UNITED STATES PATENT AND TRADEMARK OFFICE

Office Action Summary	Application No. 10/568,205	Applicant(s) MARIEN ET AL.	
	Examiner DONALD L. RALEIGH	Art Unit 2879

DETAILED ACTION

FIG. 6

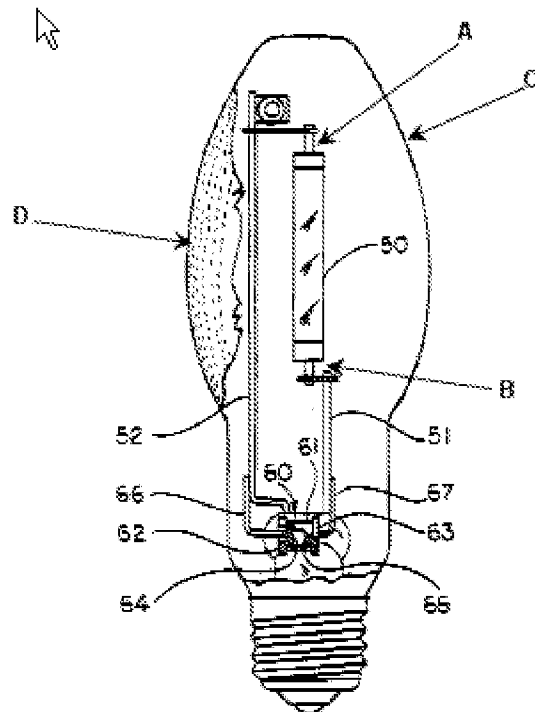
Regarding Claim 1, Gibson discloses, in Figure 6 (Above), a high-pressure discharge lamp (title) comprising: an outer envelope (C) in which a discharge vessel (50) is arranged around a longitudinal axis, the discharge vessel (50) enclosing, in a

gastight manner (Column 7, line 10), a discharge space (the inside of 50, shown in figure 5) provided with an ionizable filling (the sodium halide), the discharge vessel (50) having a first and a second mutually opposed neck-shaped portion (A and B) through which a first and a second current-supply conductor respectively, extend (shown terminating on the electrodes in figure 5), the outer envelope (C) having a bulb-shaped portion (see Figure 6) adjacent the discharge space, the bulb-shaped portion (of C) having a wall thickness d_1 , the remainder of the outer envelope (C) having a wall thickness d_2 , wherein the high-pressure discharge lamp does not comprise a shield for containing a burst of the discharge vessel(figure 6 has no containment shield).

Regarding Claim 6, Gibson discloses in Figure 6, a high-pressure discharge lamp comprising: an outer envelope wherein the ratio of the distance d_e between the electrodes to the height h_{dl} of the high- pressure discharge lamp measured along the longitudinal axis lies in a range of: $0.02 \leq d_e/h_{dl} \leq 0.2$.
